DESIGN #	DRAWN BY CP	DART AEROSPACE LTD HAWKESBURY, ONTARIO, CANADA	
CHECKED #	APPROVED #	DRAWING NO. DSI 9223	REV. A SHEET 1 OF 1
DATE 01.11.19		TITLE WEARPLATE INSERTS	SCALE NTS
A	01.11.19	NEW ISSUE

DART SERVICE INSTRUCTION

TO AMEND INSTALLATION INSTRUCTIONS

IIN-D120-639 Rev. A

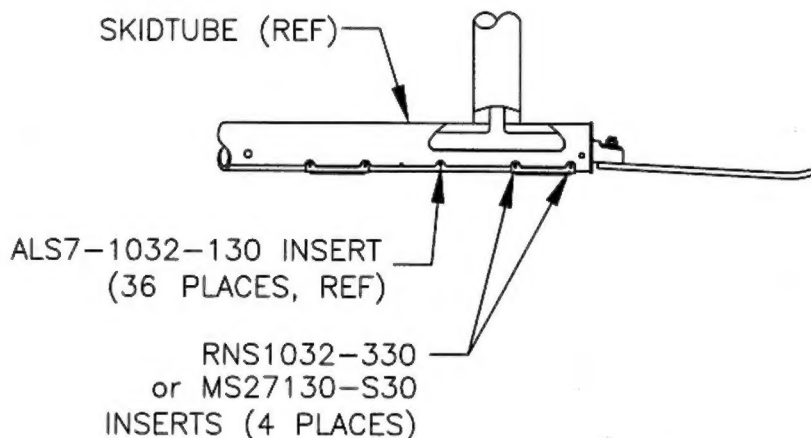
REPLACE (4) AFTMOST ALS7-1032-130 INSERTS WITH (4) RNS1032-330 / MS27130-S30 INSERTS.
UPDATE PARTS LIST AS FOLLOWS:

REPLACE:

QTY -011	QTY -013	Part Number	Description
40	40	ALS7-1032-130	INSERT

WITH:

QTY -011	QTY -013	Part Number	Description
36	36	ALS7-1032-130	INSERT
4	4	RNS1032-330 or MS27130-S30	INSERT

NOTE: OPEN HOLES TO $\phi 0.250$ INSTEAD
OF $\phi 0.297$ FOR THESE 4 INSERTS
